WORK ORDER NON-CONFORMANCE / UPDATE

Work Order: <u>1310SY</u>	DISPOSITION Rework ☐ Scrap ☐ Use-as-is ☒ Suspected Unapproved ☐	AGAINST DEPARTMENT/PROCESS			
Part No. <u>D3417-5</u>		Skid-tube ☐	Crosstube ☐	Water Jet ☐	Engineering ☐
NCR No. <u>15-5306</u>		Machining ☒	Small Fab ☐	Prod. Eng. Coord. ☐	Quality ☐
		Thermoforming ☐	Finishing ☐	Rec/Store/Packaging ☐	Other ☐
		Large Fab ☐	Composite ☐	Supplier ☐

Item ID: D3417-5 Accept *N900040100* Setup Start *NS1*
 Revision ID: Stop *NS2*
 Item Name: Washer
 Start Date: 3/19/15 Start Qty: 40.00 *40* Cust Item ID:
 Required Date: 3/26/15 Req'd Qty: 40.00 *40* Customer:
 Reference:

D3417-5 WASHER

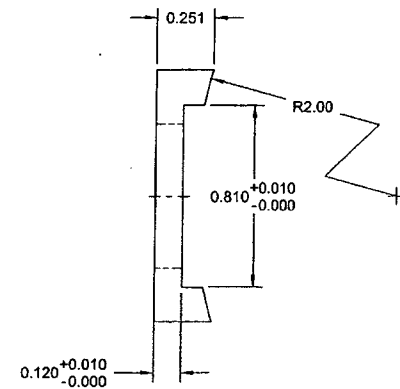
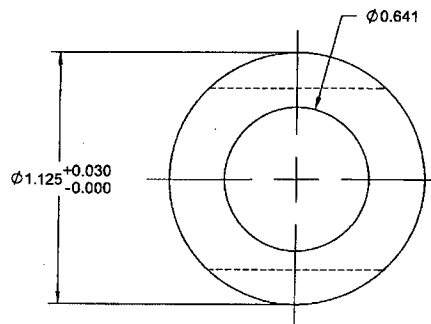
Root Cause	Date	Step	Qty	Description of work order update or non-conformance	Initial Chief Eng	Action Description	Sign & Date	Verification	QC Inspector
Design									
Doc/Data									
Equip/Tooling									
Handling/Pre									
Material									
Operator	15/04/01	120	42	0.810 groove has a .032" rads in both corners instead of square corners on all 42 parts	DAS 12 9-89 15/9/22	use as is	15-04-01 DAVID ROY	DAS 08 9-89 15/03/01	DD 150401
Offset/Setup									
Process									
Supplier									
Training									
Transport									
Unapproved

Landing Gear ☐ Bending ☐ Centre Not Concentric ☐ Cracks ☐ Crimp/Kink/Ripple/Wave ☐ Cuffs ☐ Crushing ☐ Heat Treat ☐ Inspection Strip in Tube ☐ Marks/Chatter ☐ Turning Sequence ☐ Wave/Twist in Tube	General ☐ Bend ☐ BOM/Route ☐ Broken/Damage/Defect ☐ Burrs ☐ Contamination ☐ Countersink ☐ Cut Too Short ☐ Drawing ☐ Drill Holes ☐ Finish ☐ Fit/Function	☐ Folio/Program ☐ Grain ☐ Hardware ☐ Inspection Incomplete/Unqualified ☐ Instructions Incomplete/Unclear ☐ Misaligned/off center ☐ Mislabeled ☐ Misread ☐ Off-set ☐ Out of Calibration ☐ Out of Sequence	☐ Outside Dimensions ☐ Over/Under tolerance ☐ Part Incorrect ☐ Part Lost/Missing ☐ Part Moved ☐ Positioned Wrong ☐ Power Loss/Surge	☐ Pressure/Forced ☐ Set-up ☐ Temperature/Cure ☐ Weld ☐ Wrong Stock Pulled ☒ Other
<u>wrong tool used</u>
